ADDENDUM NO. 2

City of Union City, Indiana First Floor Vision Corner MEP Improvements

September 28, 2022

TYPICAL FURNACE DETAIL

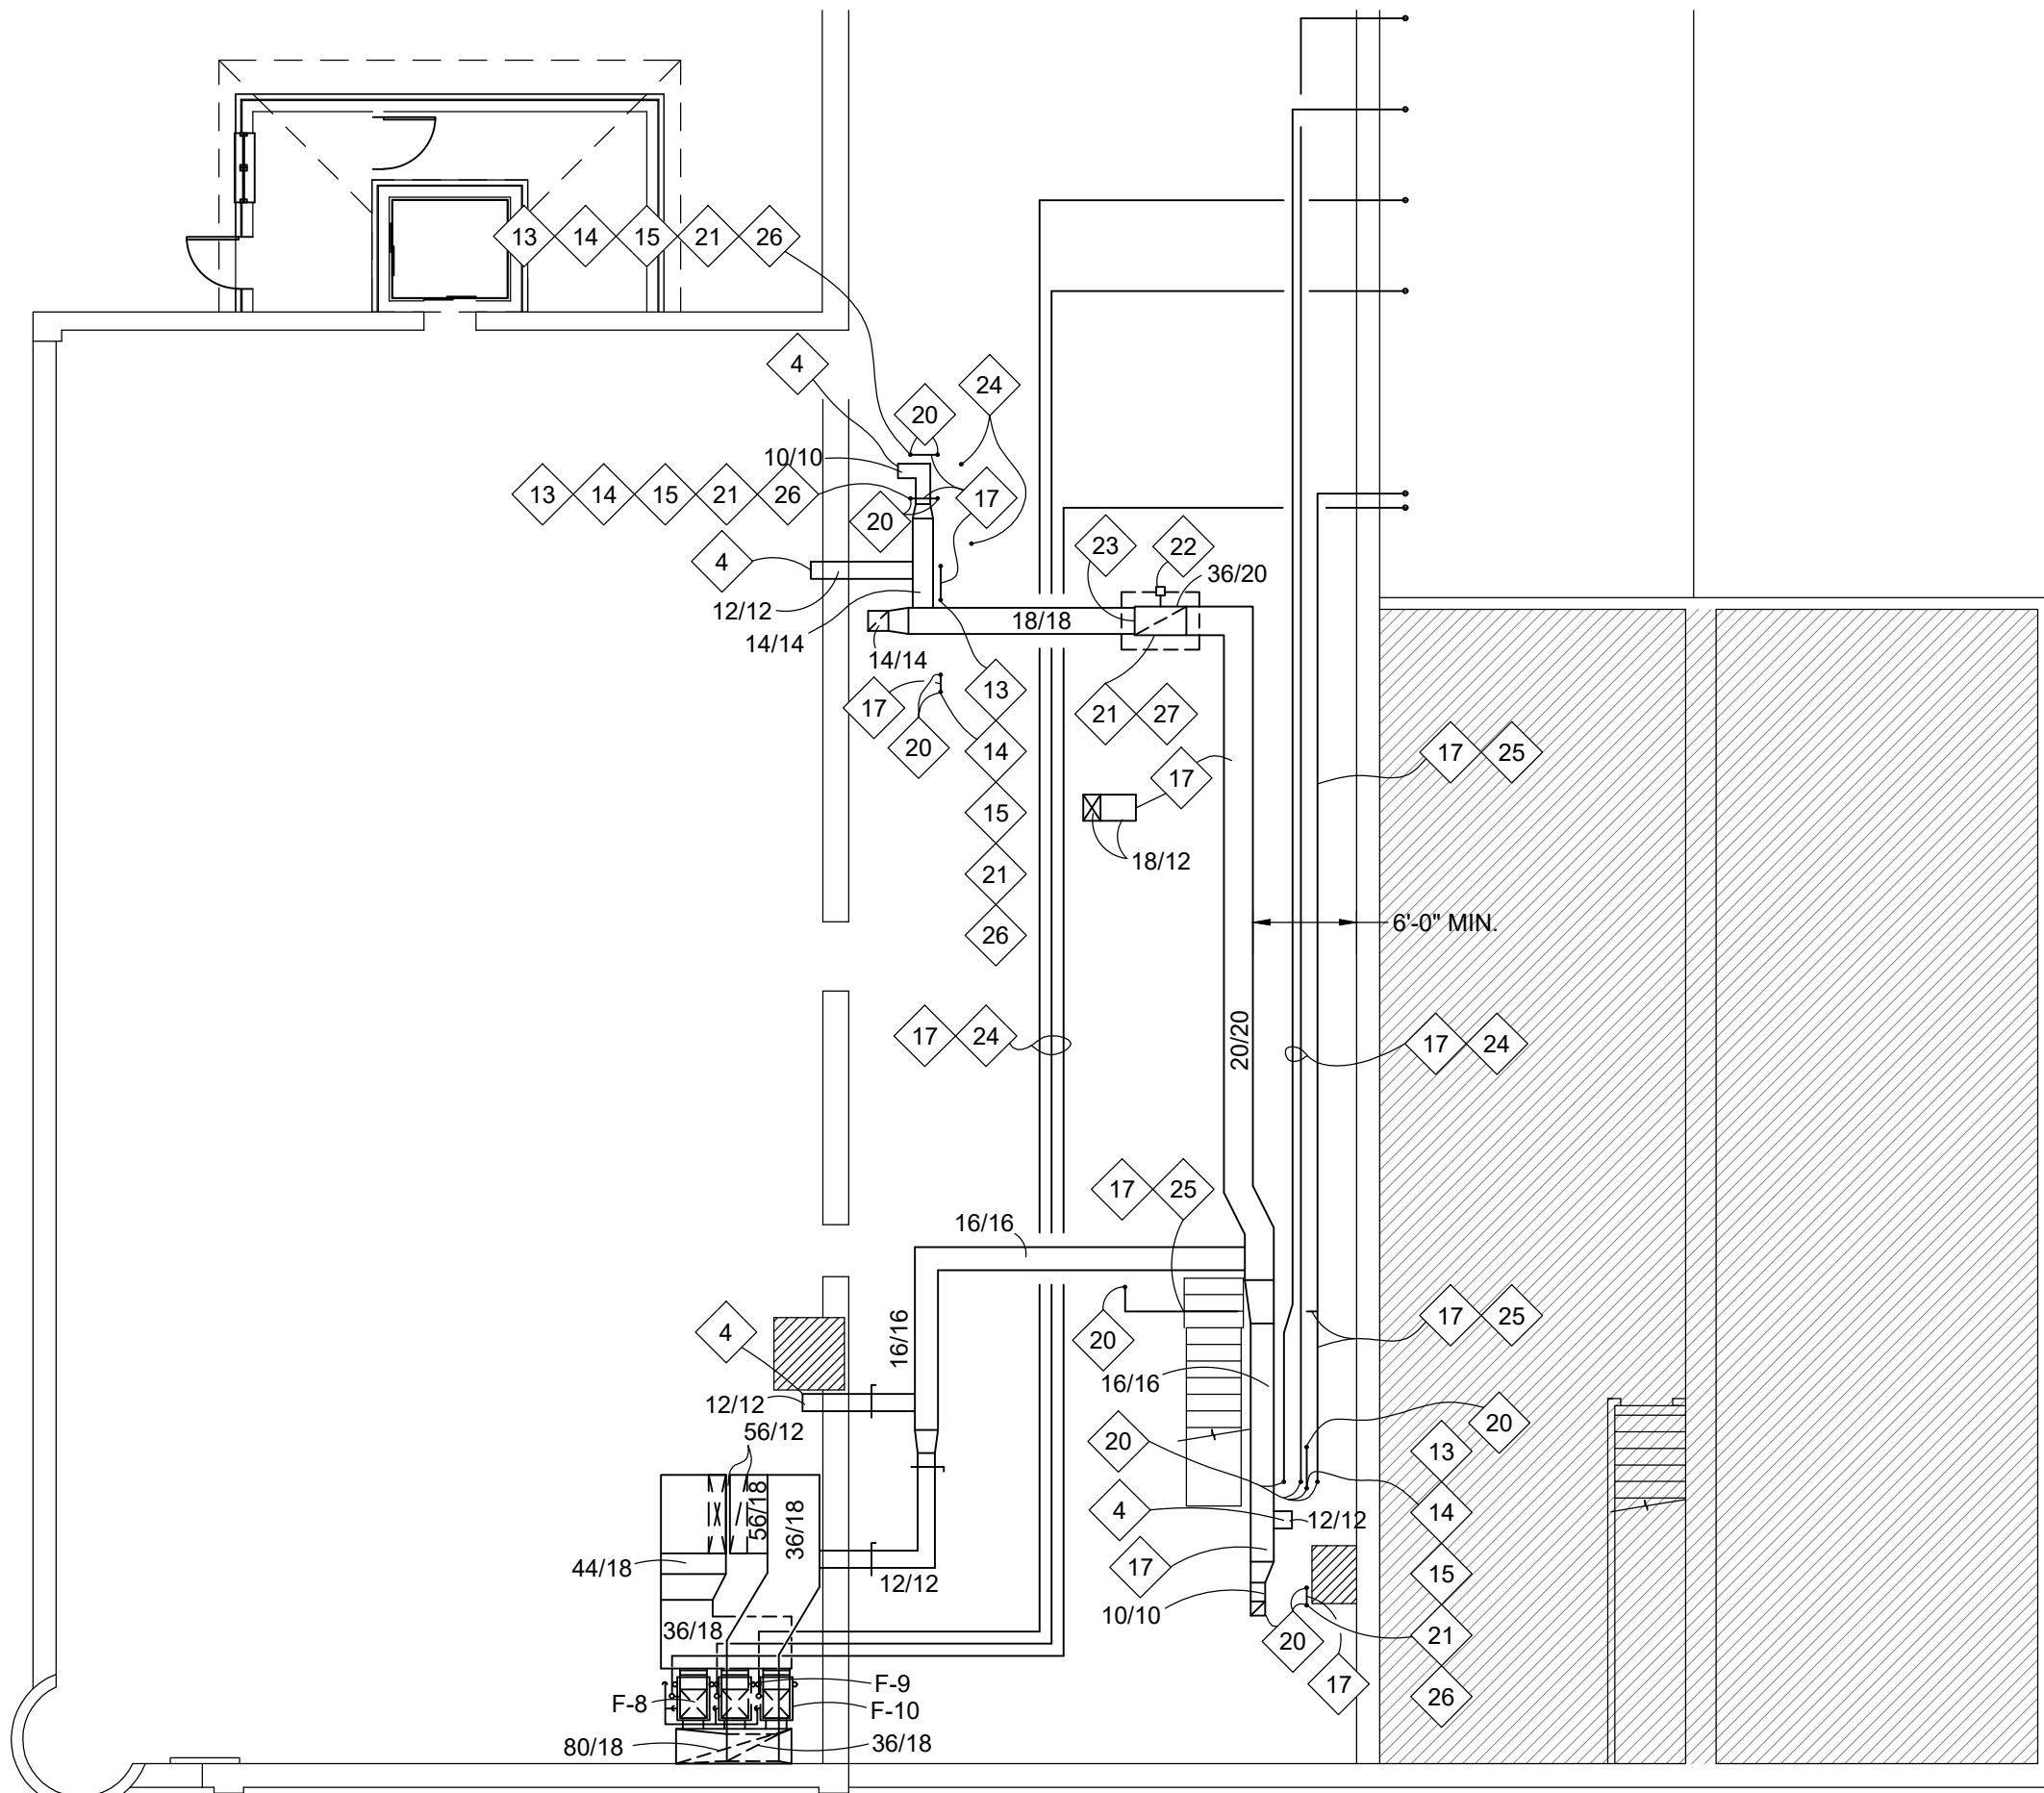
1. **DRAWING NO. M0-01R, MECHANICAL NOTES, SCHEDULES, DETAILS**
TYPICAL FURNACE DETAIL: The attached sheet M0-01AD2 containing a revised TYPICAL FURNACE DETAIL shall replace the detail on sheet M0-01R of the bid set of plans dated 5-25-22.

WHERE INDICATED, PROVIDE 2'-0" TALL ACOUSTICALLY LINED RETURN AIR PLENUM CONSTRUCTED FROM WELDED, PAINTED 1 1/2" x 1 1/2" x 1/8" STEEL ANGLE FRAME WITH SHEET METAL ENCLOSURE

ENLARGED ROOM 205 MECHANICAL PLAN

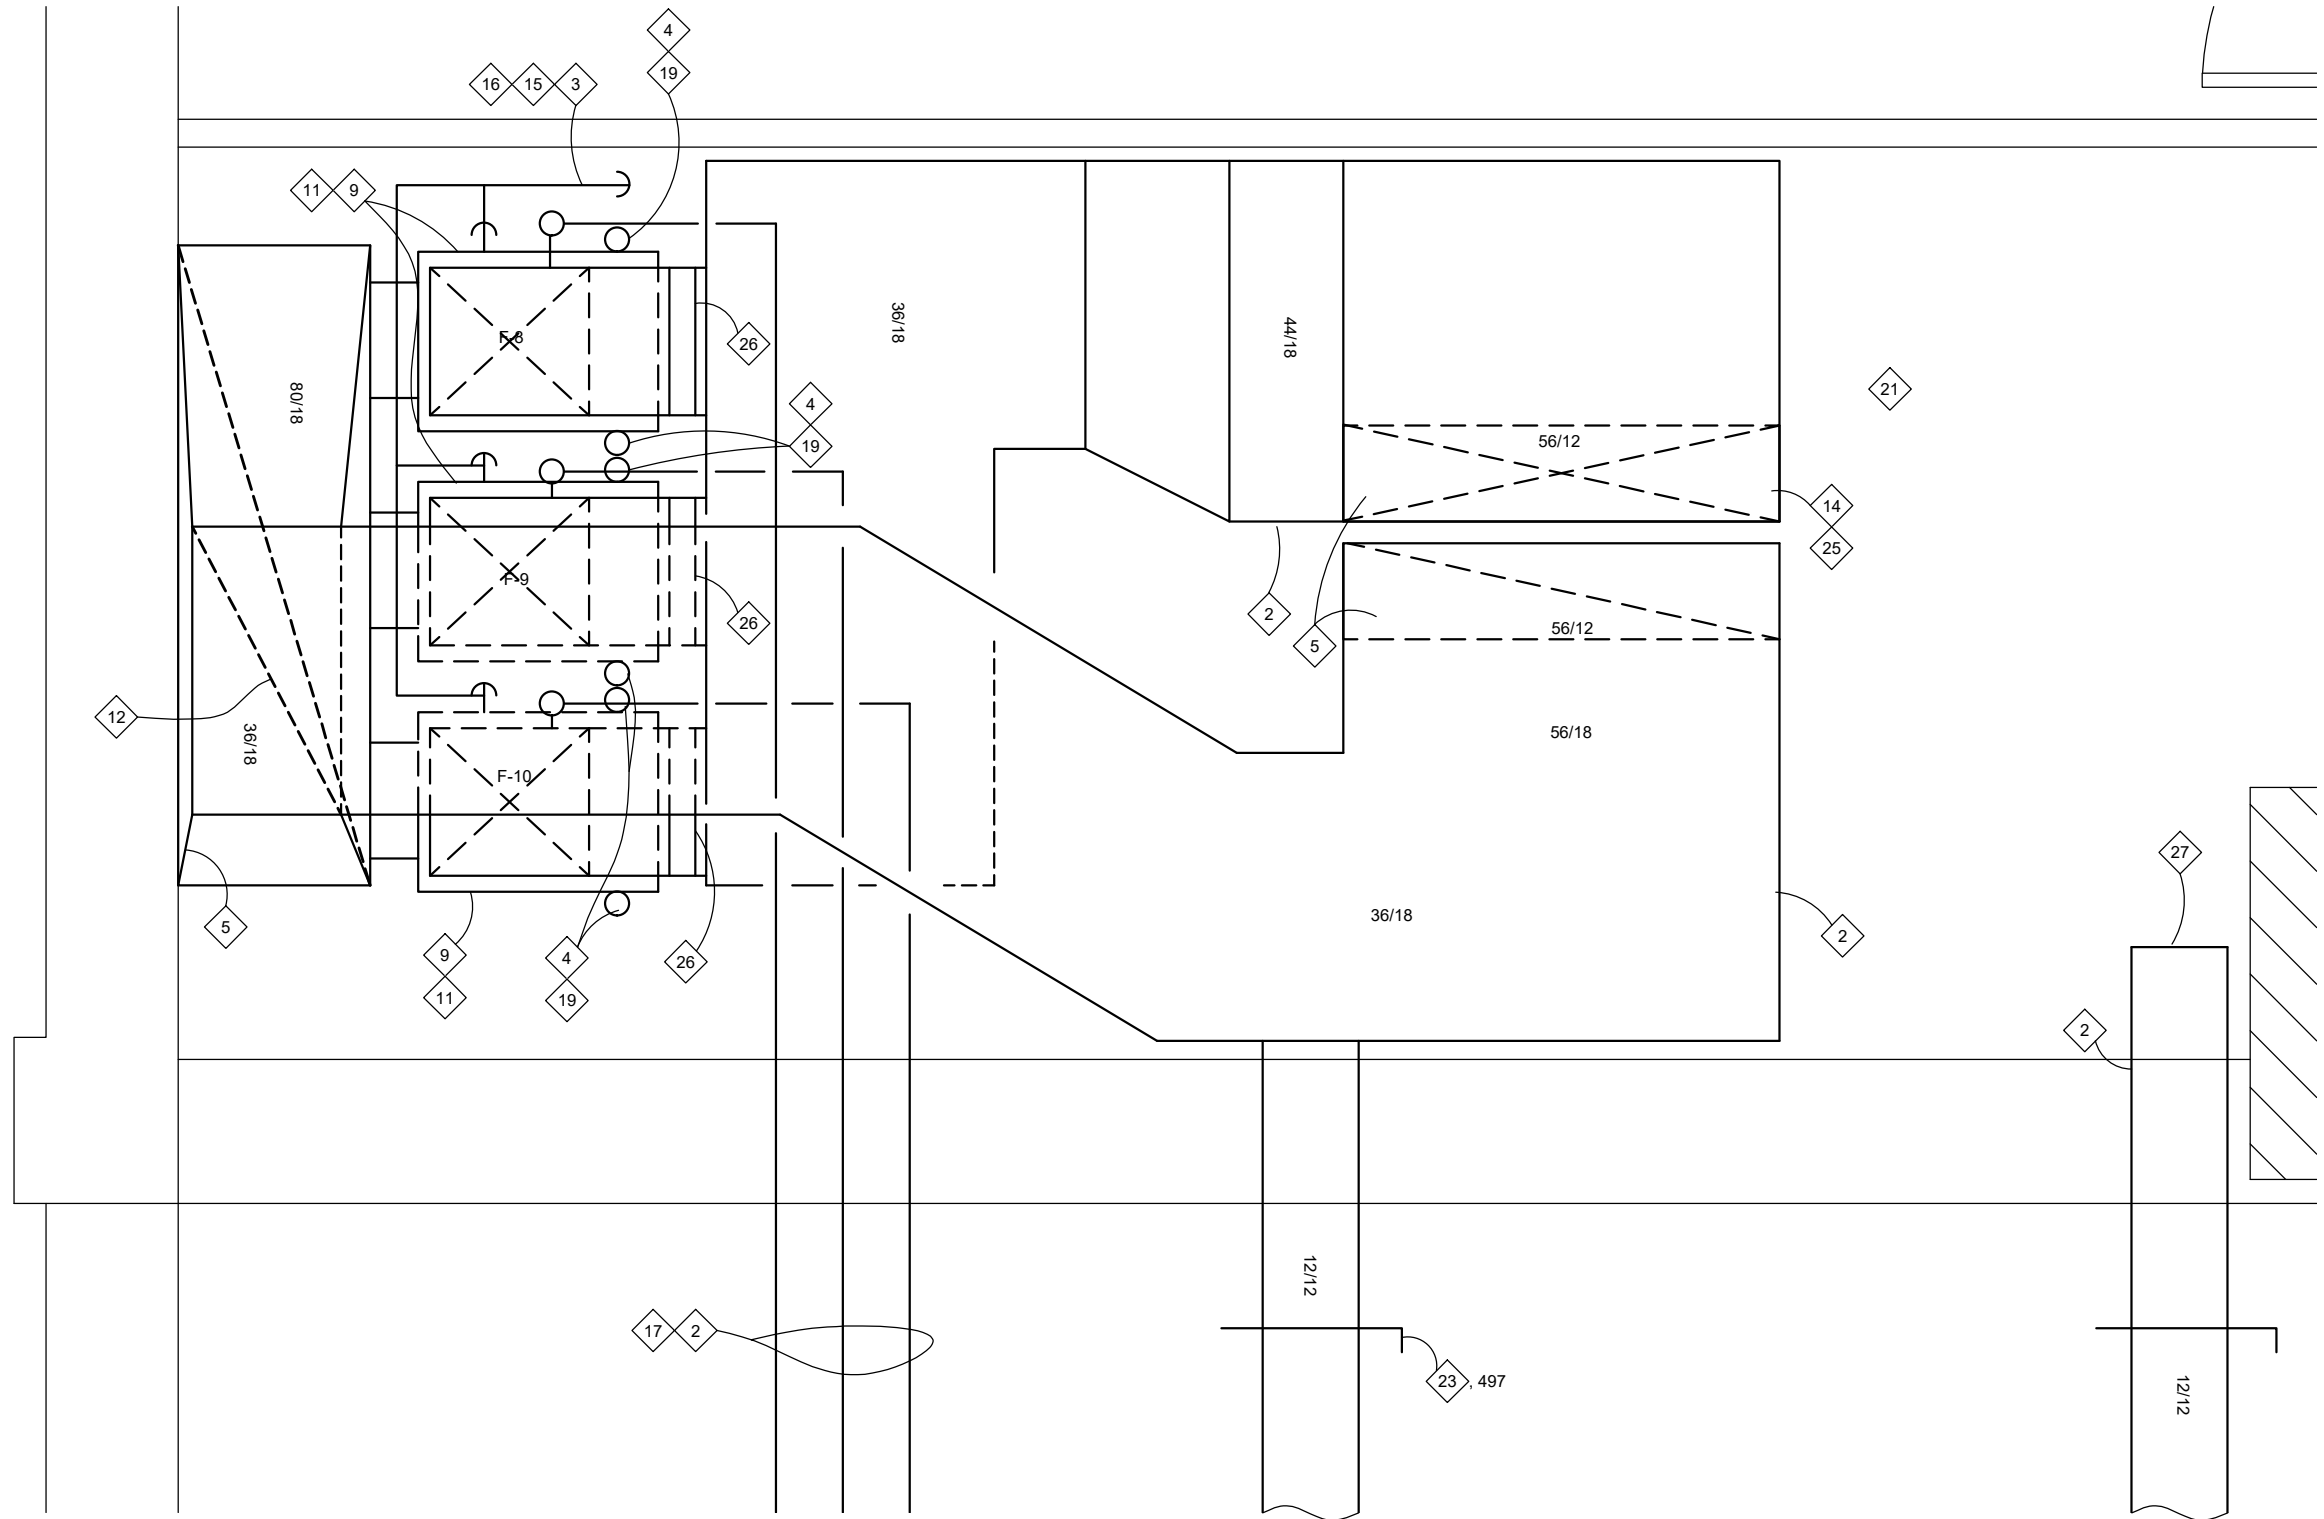
3. **DRAWING NO. M2-01R, ENLARGED MECHANICAL PLANS**
ENLARGED ROOM 205 MECHANICAL PLAN – The attached sheet M2-01AD2 containing the ENLARGED ROOM 205 MECHANICAL PLAN shall replace the ENLARGED ROOM 205 MECHANICAL PLAN detail on sheet M2-01R of the bid set of plans dated 5-25-22.
